MS-16GN 10

MICRO-STAR INT'L CO.,LTD.	
Title	
HUDSON PCIE/CLK/FCH	
Size	Document Number
Custom	MS-16GN1
Date:	Wednesday, May 04, 2011
Sheet	9 of 41
Rev	0.A

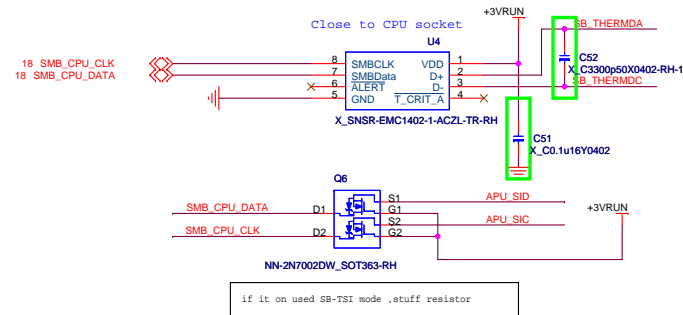
change U10,C229,R145,R146 to NC

2010/10/26 Change C51,C52 to NC

HDT Hardware Debug

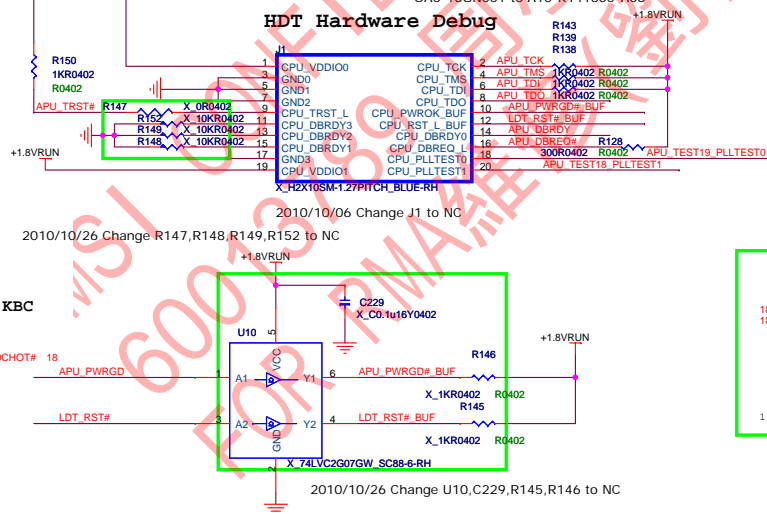
2010/10/26 Change R147,R148,R149,R152 to NC

2010/10/26 Change U10,C229,R145,R146 to NC

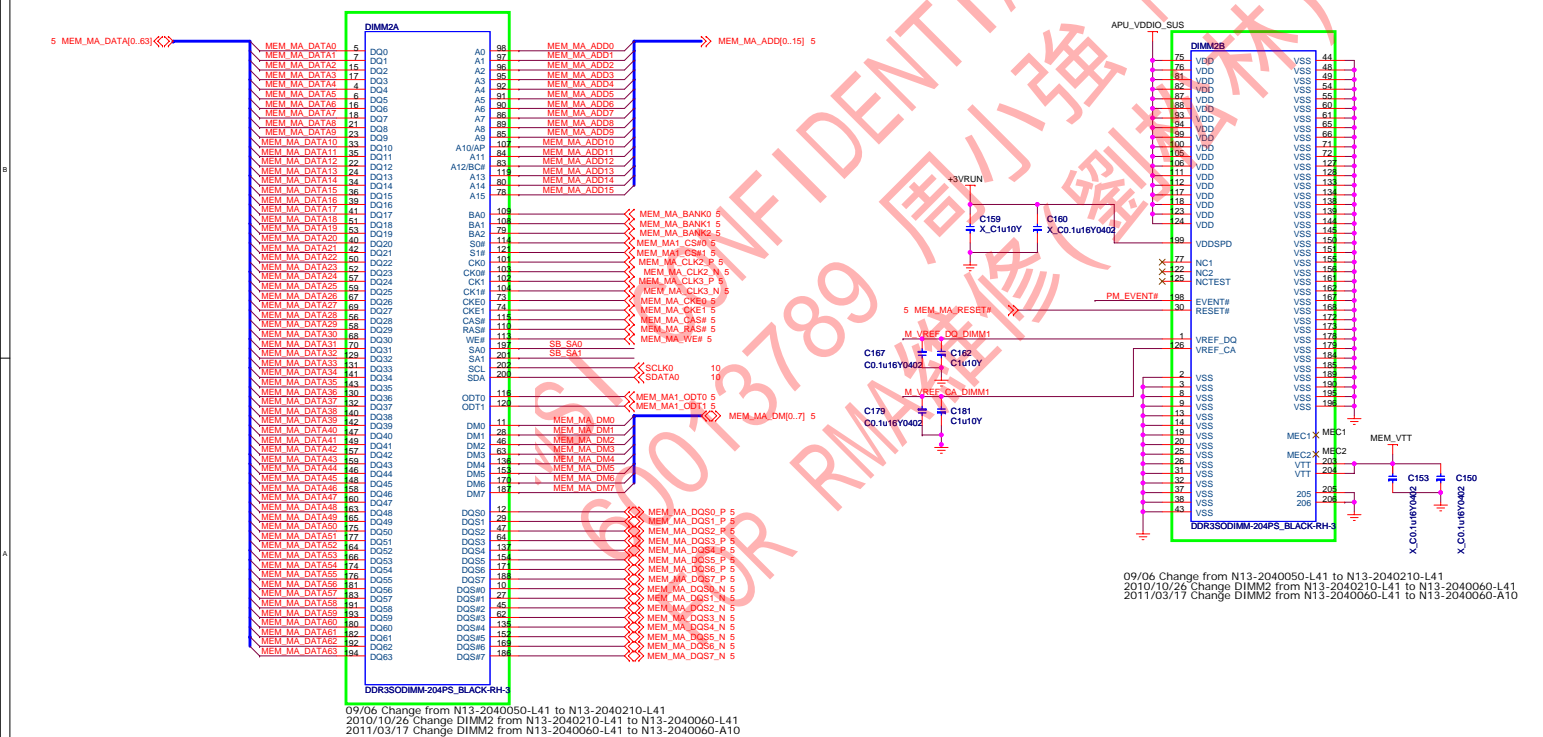
09/06 Change from N13-2040050-L41 to N13-2040210-L41
2010/10/26 Change DIMM2 from N13-2040210-L41 to N13-2040060-L41
2011/03/17 Change DIMM2 from N13-2040060-L41 to N13-2040060-A10

(16GNA) - CRT/USB2.0/GLAN

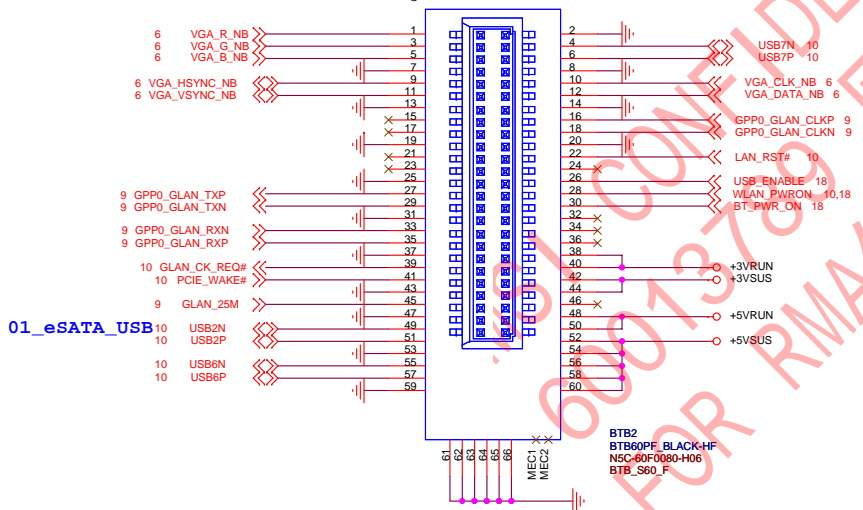
2011/02/23 Change Q14 from D03-0700249-P03 to D03-0700299-F09 for costdown

JBAT1 Pin Definition

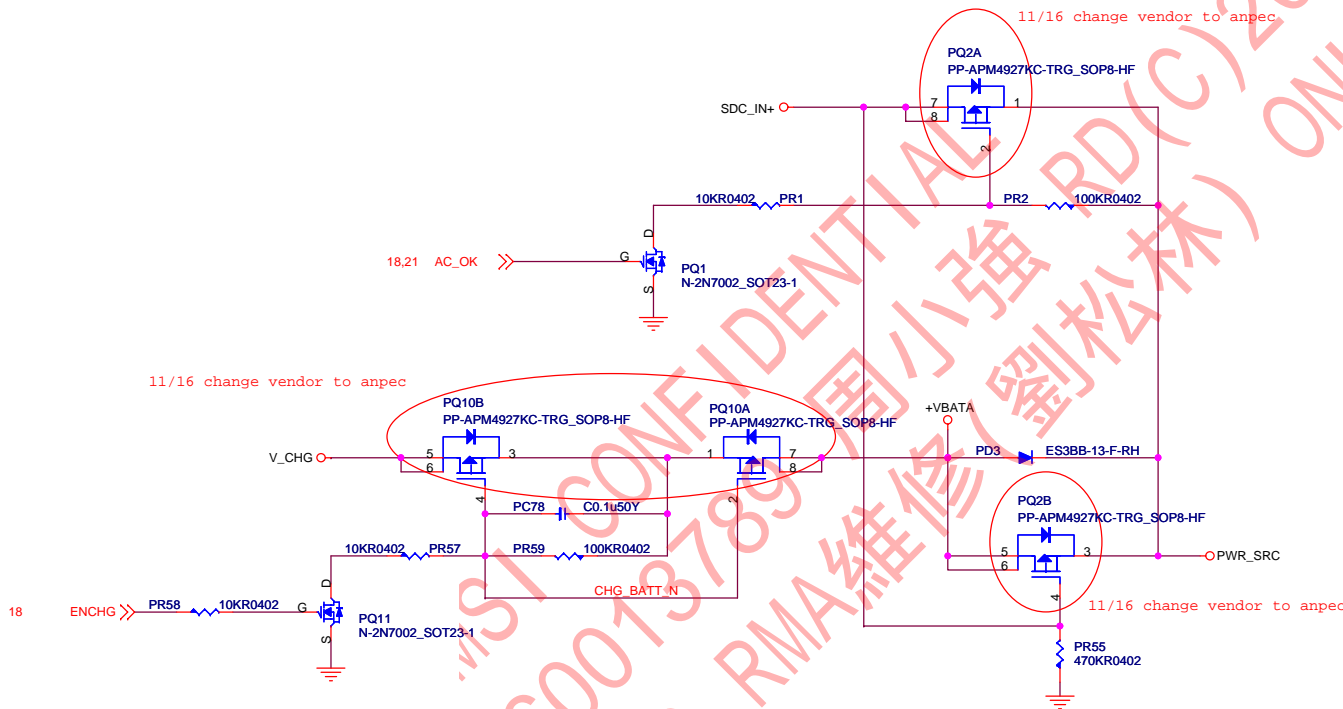
2010/10/06 Change JBAT1 from N91-09M0041-AF2 to N91-09M0231-AF2
